CU/SDR 20-06 ACOM Consulting Public Hearing File – Part I

**CITY OF DUNDEE CITY COUNCIL
Staff Report**

**Appeal of a Planning Commission Order Denying a
Conditional Use Permit and Site Development Review
File No. CU 20-06/SDR 20-07 – Verizon Cell Tower**

PROPOSED OVERALL SITE PLAN | 1

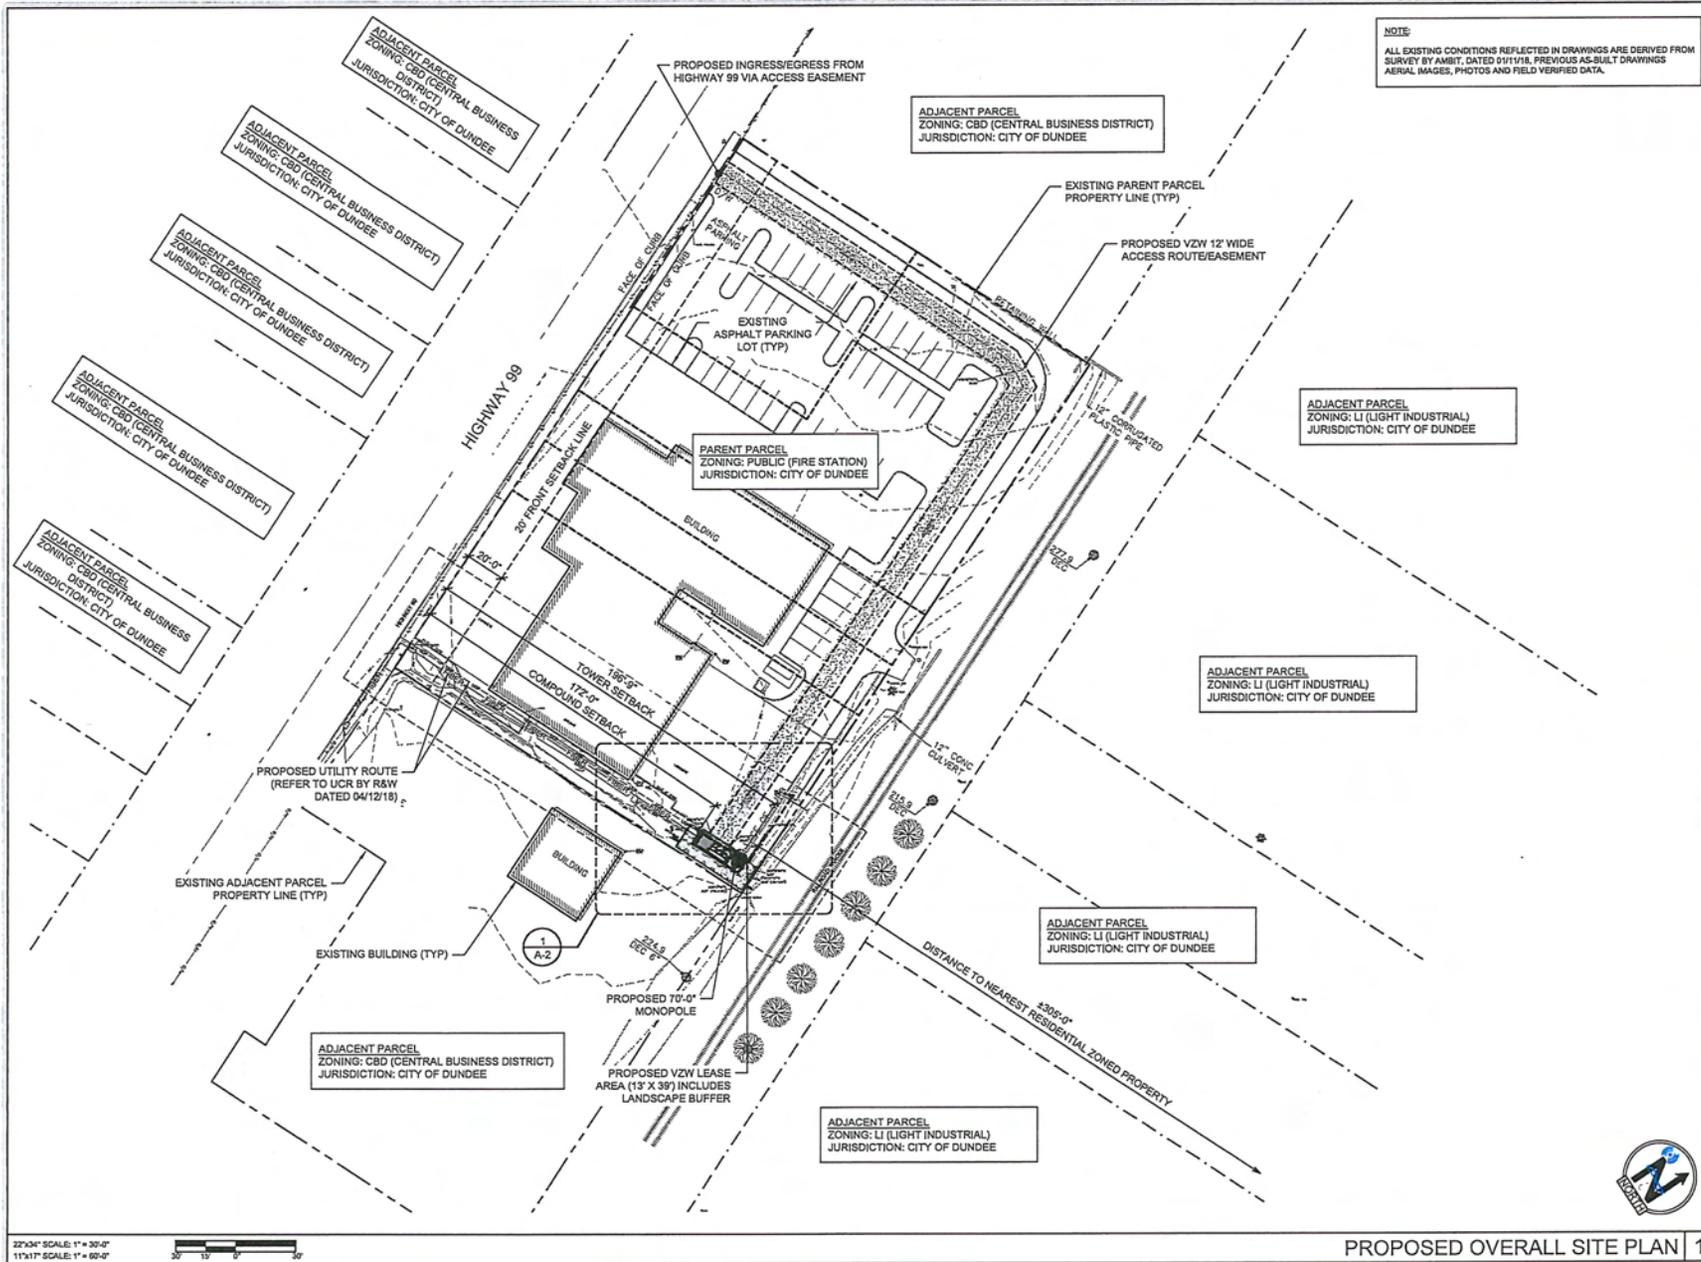
The additional electronic file dated 7/27/20 submitted by Acom, Consulting, Inc., showing 14-pages of plans and elevations, includes Sheet SV-2, showing the distance from the tower to the property line on the east side of Maple Street where the residential zoning begins is 328.7 feet, which exceeds the 300-foot requirement.

Figure 2: Noise Barrier - Plan

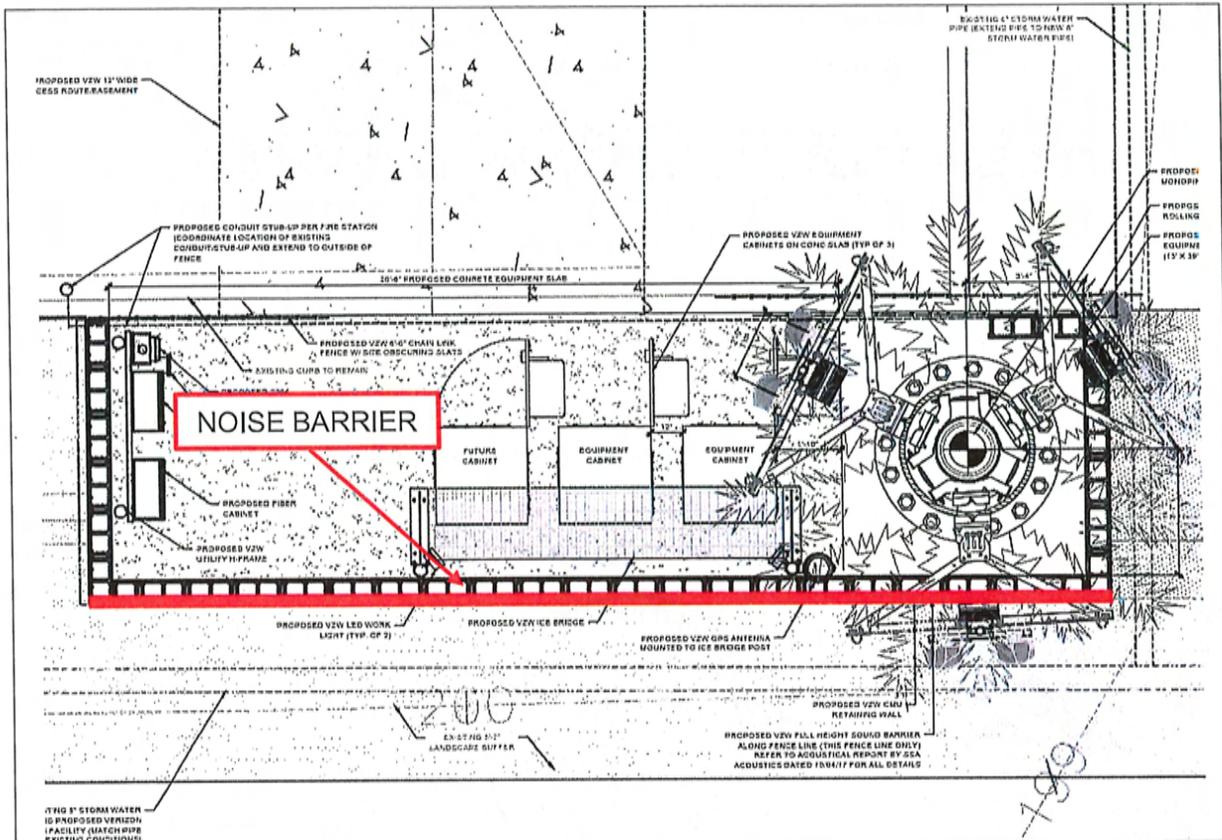
The above proposed condition of approval related to the noise barrier is now not needed because the updated June 16, 2020 noise study includes plans showing how the noise barrier will be affixed to the chain link fence. Therefore, where the City Council approves the CU and SDR applications, the above condition of approval is not included in the conditions of approval at the end of this staff report.
